PREVOST

Instruction Sheet

IS-97051

Antenna Replacement for the H and XL Coaches

Figure 1: Sectional view of the new antenna. **(1)** Vehicle roof; **(2)** Parcel rack bottom wall; **(3)** Antenna; **(4)** Antenna base; **(5)** New tab terminal (#561626); **(6)** Cable connected to the FM-AMP 12 V #15; **(7)** Adapter to be added; **(8)** Existing cable connected to the radio .

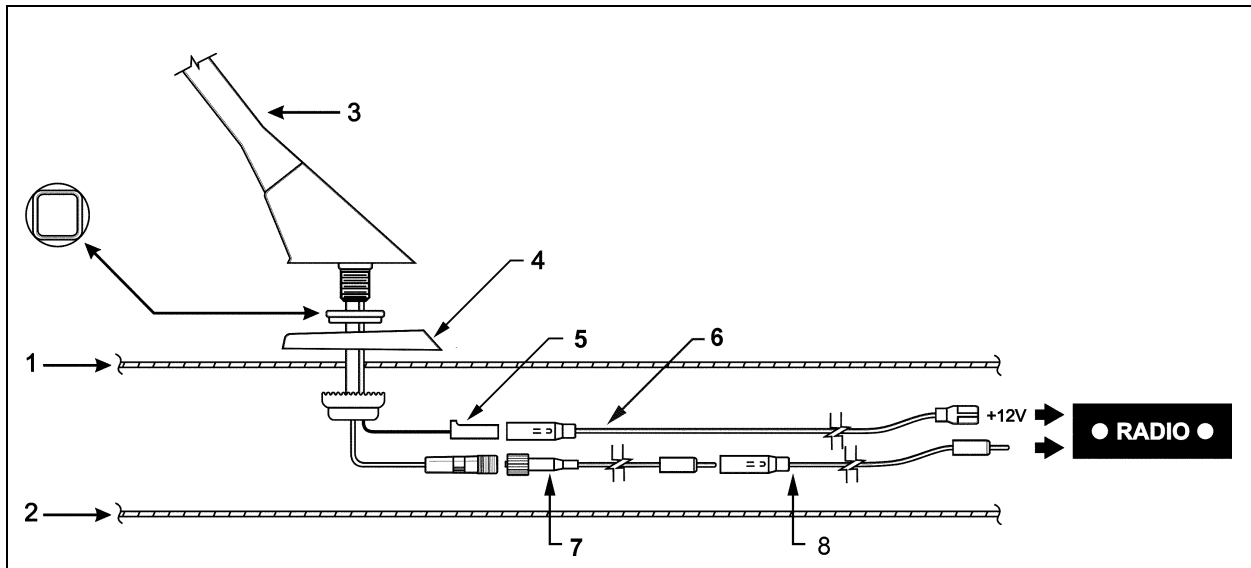
1. Open the first compartment on the driver's side. Remove the white cap on ceiling of this rack. Unscrew the antenna nut and remove the antenna;
2. Assemble the new antenna (item 3, figure 1) to its base (item 4, figure 1);
3. Plug new adapter #900916 (item 6, figure 1) in between the new antenna cable and the existing cable routing to the radio (item 7, figure 1). If needed, secure the wiring with cable ties;
4. Remove the terminal from the antenna's blue wire. Replace this terminal with tab terminal 561626. Refer to figure 1, item 5;
5. Seal the new antenna and its base to the coach top using Sika 221 in order to avoid water leakage. Retighten the antenna nut;
6. Replace the white cap in the parcel rack.

1. Open the second parcel rack on the driver's side. Remove the white cap on ceiling of this rack;
2. Untighten the antenna nut and remove the antenna;
3. Assemble the new antenna (item 3, figure 1) to its base (item 4, figure 1);
4. Plug new adapter #900916 (item 6, figure 1) in between the new antenna cable and the existing cable routing to the radio (item 7, figure 1). If needed, secure the wiring with cable ties;
5. Remove the terminal from the antenna's blue wire. Replace this terminal with tab terminal 561626. refer to figure 1, item 5;
6. Seal the new antenna and its base to the coach top using Sika 221 in order to avoid water leakage. Retighten the antenna nut;
7. Replace white cap in the parcel rack.
